RE: Eagle Road Subdivision – Preliminary Land Development

Gannett Fleming, Inc. has completed a review of the Preliminary Land Development Plans for compliance with the Radnor Township Code. The Plans were also reviewed for conformance with Subdivision and Land Development, Zoning and other applicable codes of the Township of Radnor.

Eagle Road Subdivision

MANHOLE FRAME AND COVER

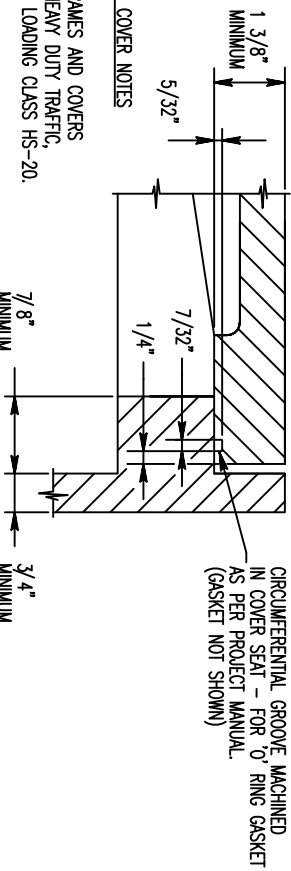
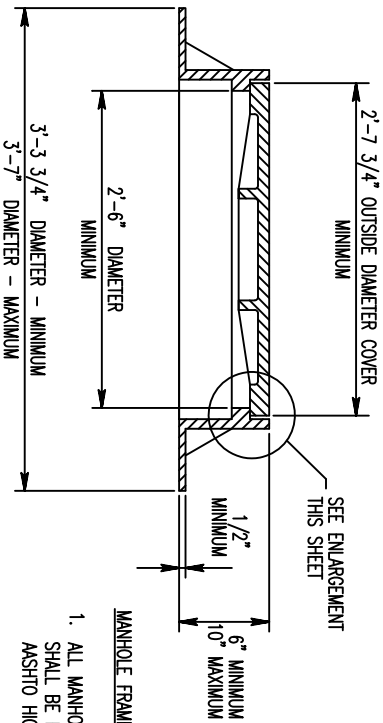
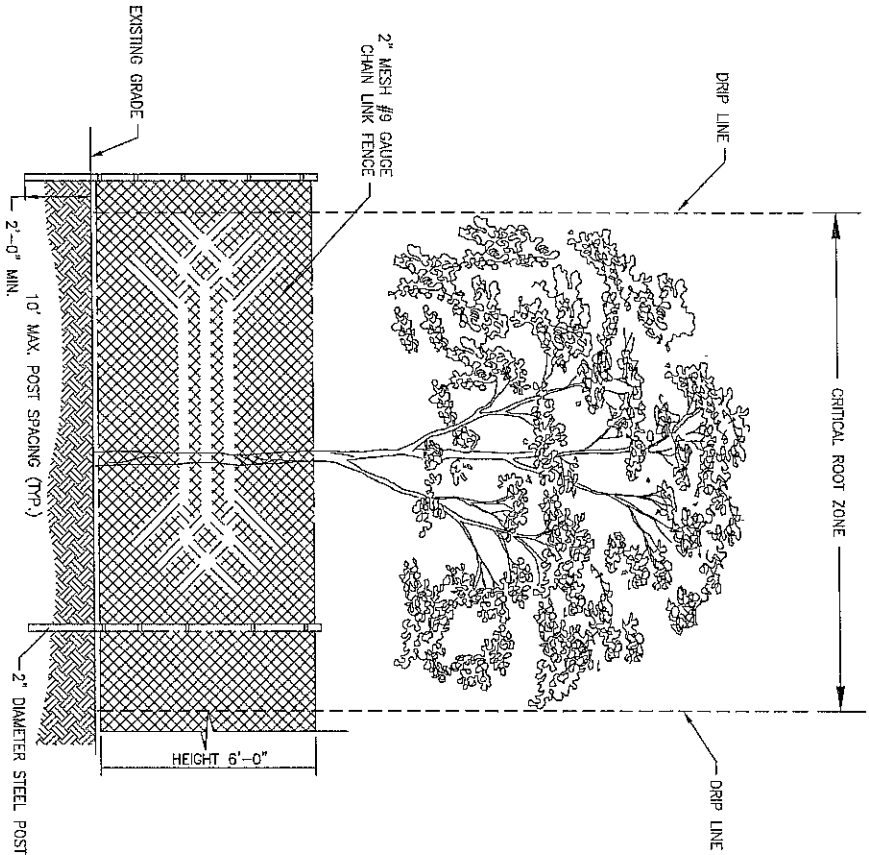
1. The sanitary sewer easement for the existing sewer must be shown on the drawings.
2. There shall be no plantings in the existing or proposed sanitary sewer easements.
3. The foundations for the houses on Lot #1 and Lot #2 appear to be less than 10 feet from the existing sanitary sewer main. The applicant must consider relocating the existing sanitary sewer main.
4. The Radnor Township frame and cover detail must be added to the plan. We have attached a copy for your use.

TREE PROTECTION DETAIL

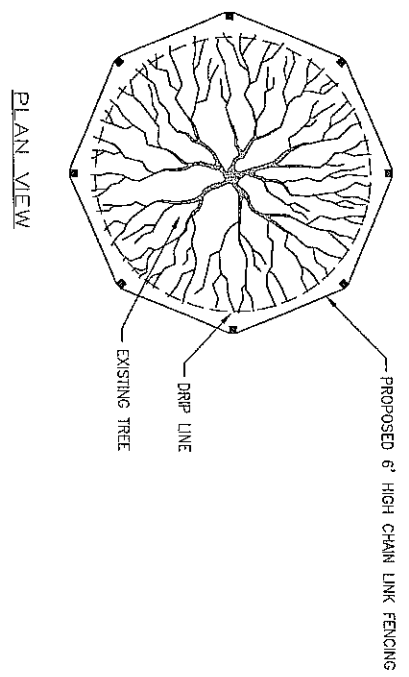
5. It must be noted who the owner of the cul-de-sac will be (Public or Private). Who will be the owner of the property along the easterly side of the cul-de-sac? It must be noted who the owner of the
6. The applicant must appear before the Shade Tree Commission and gain approval prior to this plan being presented to the Board or Commissioners.
7. The attached tree protection detail from Rockwell and Associates must be added to the plan.
